BAR 07-03-02
316-318 East Main Street
TM 28 P 42
Rehabilitation and conversion to mixed-use – former Hardware Store building
Mike Stoneking, Applicant/Octagon Partners, Owner

CITY OF CHARLOTTESVILLE BOARD OF ARCHITECTURAL REVIEW STAFF REPORT May 15, 2007

Certificate of Appropriateness Application BAR 07-03-02 316-318 East Main Street TM 28 P 42 Rehabilitation and conversion to mixed-use Mike Stoneking, Applicant/Octagon Partners, Owner

Water Street Elevation:

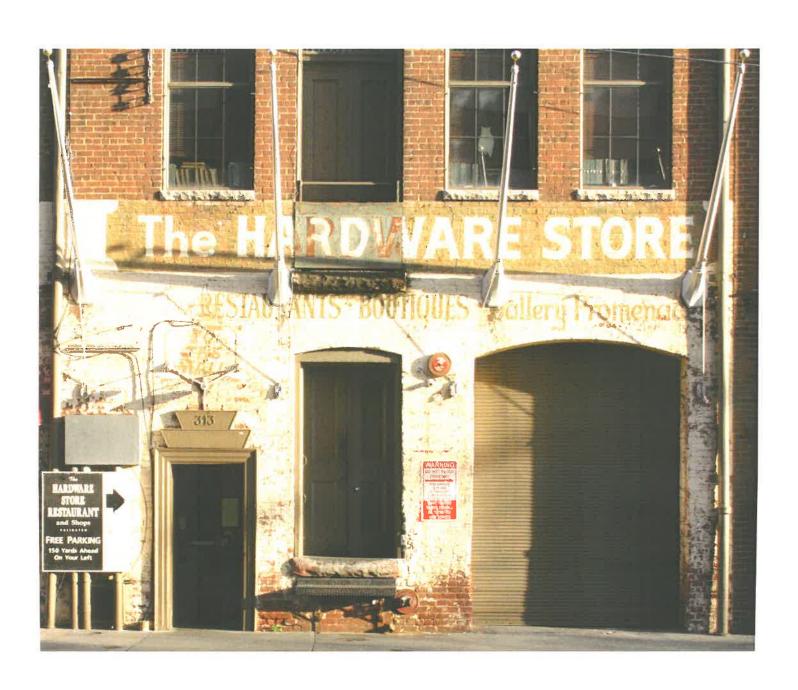
Openings-The existing steel overhead door to the loading dock will be removed and replaced with new aluminum storefront. The mullion configuration and addition of small profile muntins (Zippy Grid) are intended to recall a rail and style wood door that may have been and original component. This approach is recommended by the Department of the Interior for such conditions. A similar approach is proposed for the new entrance at the western side. The existing door will be removed and the previous arched window will be re-established serving to create the new door opening beneath.. This will be in-filled with storefront. We intend to retain the former wood loading doors at every level but cover them from the exterior in a single sheet of tempered glass. This will allow us to retain the exiting doors and provide a water-tight seal.

Electrical- The electrical service will remain in its present location. We intend to increase the size of the painted steel screen to cover more of the conduit.

Lighting- The two egress doors require lighting by code. Three sconce fixtures are proposed and product literature is attached.
